ENGINE - LP COMPRESSOR - REPLACEMENT OF NO.3 BEARING SEAL RING HOLDER - CATEGORY CODE
7 - MOD.ENG-72-0010

V2500-ENG-72-0010

Location of No.3 Bearing Seal Assembly
Fig.1

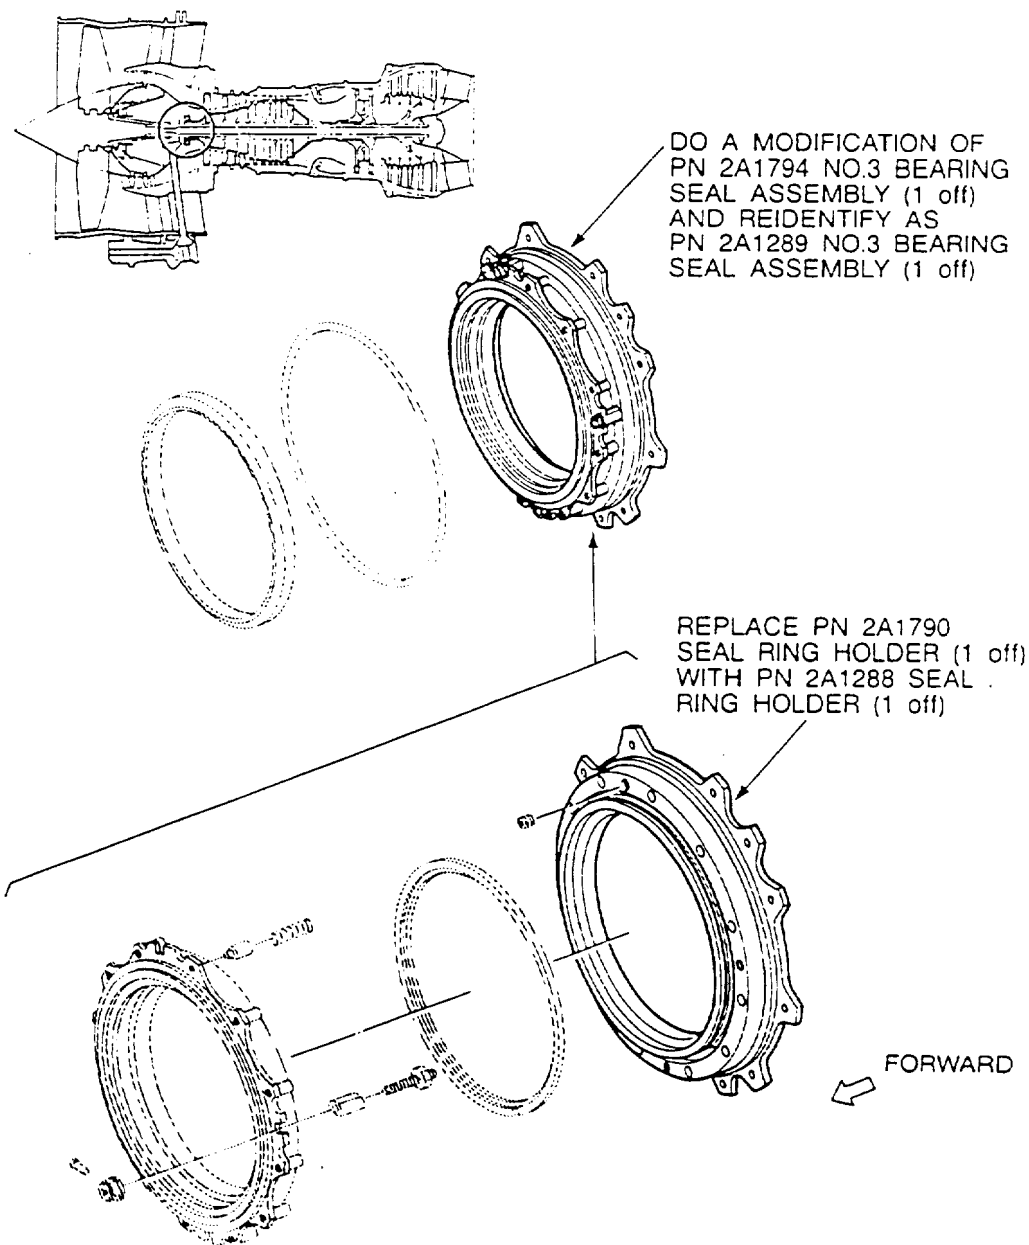
(a) 2A1288 Seal Ring Holder made of titanium supersedes 2A1790 Seal Ring Holder made of steel

(b) Existing 2A1794 No.3 Bearing Seal Assembly can be reidentified as 2A1289 by replacing the Seal Ring Holder from 2A1790 to 2A1288.

- (1) Install 2A1288 Ring Holder by Figure 1 and approved procedure in Reference (2), Chapter/Section 72-32-25, Assembly.
- (2) Reidentify 2A1794 No.3 Bearing Seal Assembly as 2A1289. Refer to Reference (3), Chapter/Section 70-09-00, Marking of Parts. Use the vibration peen method.
